SERVICE BULLETIN

M1373A

2014 TOURING ABS BRAKE LINE - SAFETY RECALL 0157

Figure 1. ABS Brake Line Cable Straps

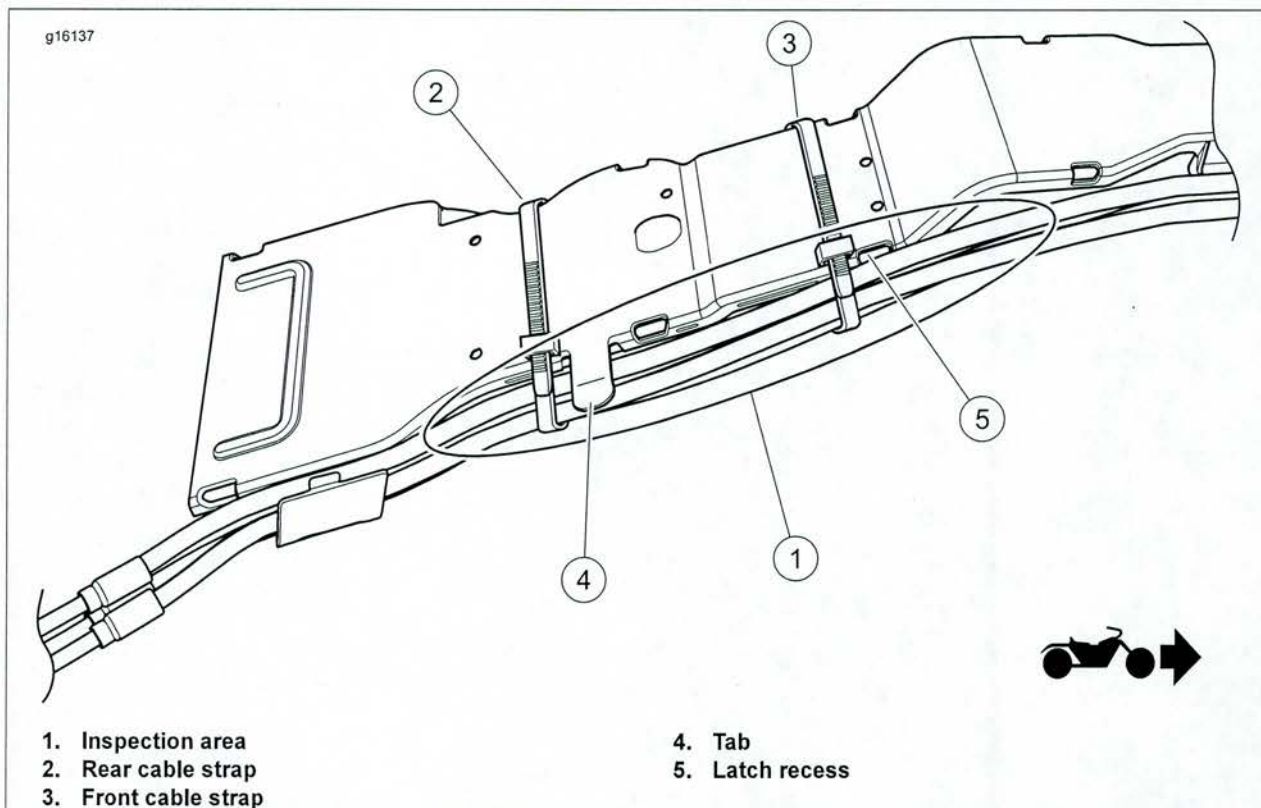
The affected motorcycles may have been assembled with a front brake line in a position where it could become pinched between the fuel tank and the frame, either at original assembly or in subsequent service activity. If a pinched brake line remains undetected it could cause front brake fluid pressure to increase while riding, possibly resulting in a front wheel lock-up.

2. Remove the seat and fuel tank. See the service manual.
3. See Figure 1. Inspect brake line routing along the wire trough. Verify that the lines are secured by two cable straps (2, 3) as shown. Motorcycles built October 14, 2013 and later will have the rear cable strap (2) already installed. Installed cable straps may be black or white in color. Both are acceptable.

4. If lines are not secured by cable straps:
 - a. Inspect lines for damage in area (1).
 - b. If line is damaged, refer to Table 2 to determine if replacement is necessary. If line replacement is required, see the service manual. The **new** line can be taken from dealer inventory or ordered using the included order form.

- c. Verify that lines are properly routed under tab (4).
 - d. Secure lines with one or two **new** cable straps (2, 3) (Part no. 10039) as required. Locate rear cable strap (2) within 1/2 in (13 mm) rearward of tab (4). Locate front cable strap (3) at or near latch recess (5).
